Overview: Production error; immobilizer wire (orange/black) in pin position #4 instead of pin position #5. Although an effort to correct the issue was made, some quantity of harnesses did get shipped before the issue was spotted. We are advising to inspect the harness BLADE connector before attempting to install the harness and program the module.

Descripción general: El nuevo arnés en T FTI-STP1 requiere modificaciones para su uso en aplicaciones de transmisión automática (AT).

FTI-STP1: Notas de instalación y configuración

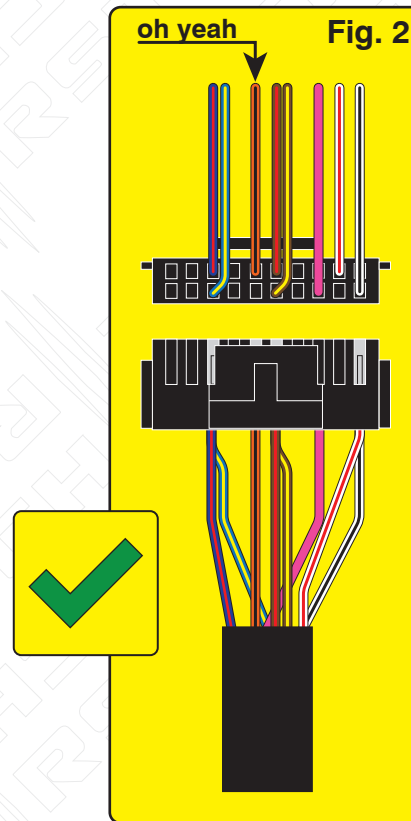
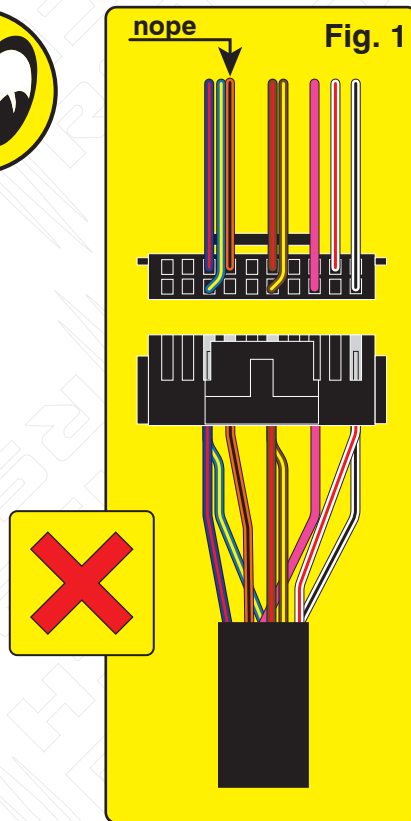
Issue: Module fails to program to vehicle, will not allow the vehicle to be remote started.

Correction: Step 1.) Locate the orange/black wire and confirm whether it is positioned as illustrated in Fig. 1 or Fig. 2. If the wire is as illustrated in Fig.1, proceed with Step 2 through 5 and complete the repair procedure outlined, if the wire is as illustrated in Fig. 2, correction is not necessary, proceed with harness installation and module programming.

Step 2.) Using a pick, lightly depress the catch that secures the terminal in the housing then remove the wire and terminal from the housing.

Step 3.) Using a fine tip razor or utility knife, insert the blade beneath the terminal catch and raise it slightly, so that it can be reused to secure the terminal when reinserted into the BLADE connector housing.

Step 4.) Refer to Fig. 2 for correct position of the orange/black wire (next to brown/red) then reinsert the terminal, pressing lightly until the catch 'snaps' into place, securing the terminal in the connector housing.

MODIFICACIÓN REQUERIDA PARA APLICACIONES DE TRANSMISIÓN AUTOMÁTICA ÚNICAMENTE

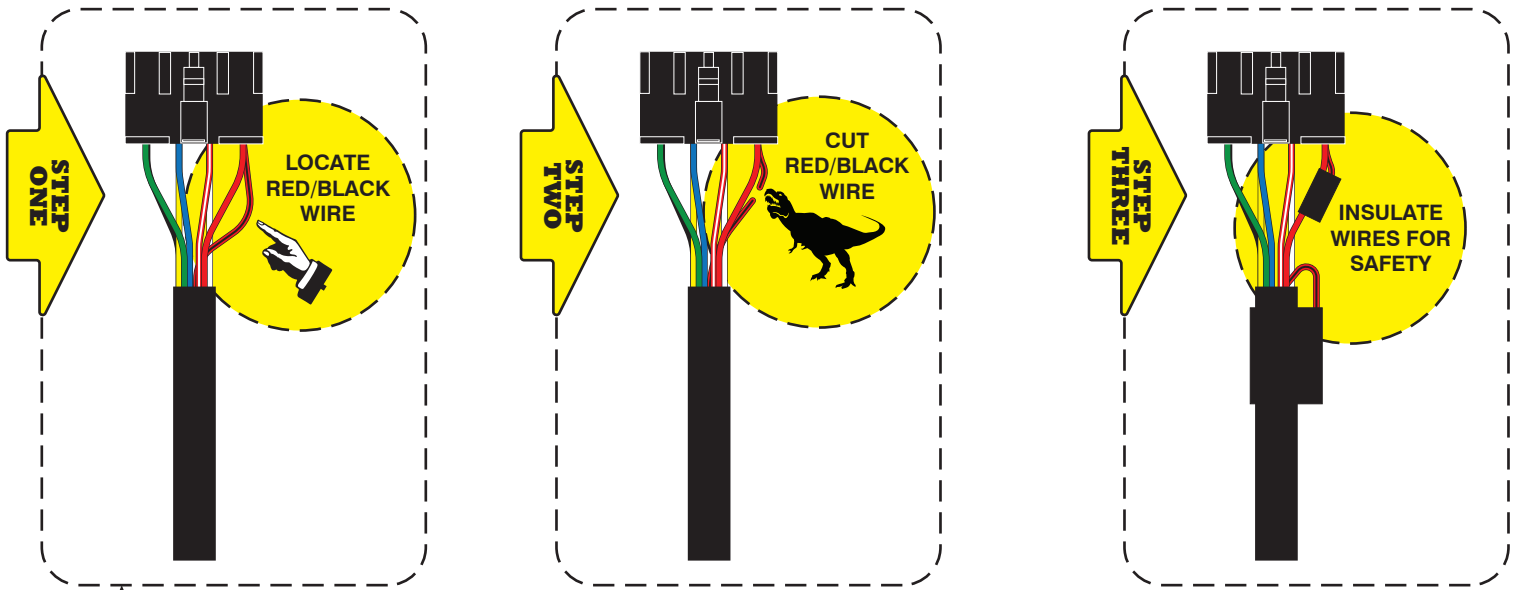
Problema: El arnés en T FTI-STP1 ha sido diseñado para ser compatible con AT (transmisión automática) y MT (transmisión manual), pero debido a una supervisión de la producción, el mecanismo de selección se estableció por defecto en el modo MT.

El uso de un arnés configurado para una aplicación MT, en un vehículo equipado con AT, podría provocar daños en el módulo del vehículo. Se recomienda que el arnés vuelva al modo AT antes de instalarlo en vehículos equipados con transmisión automática.

Corrección: Localice el cable rojo/negro (+ embrague) provisto en el conector CN1 del conjunto del arnés principal. Corte el cable rojo / negro, ya sea al ras del conector CN1 o dejando suficiente cable expuesto para que pueda aislar y asegure los extremos del alambre que quedan después del corte. Aísle cada uno de los extremos restantes del cable rojo/negro y asegúrelos para evitar cualquier posibilidad de cortocircuito.
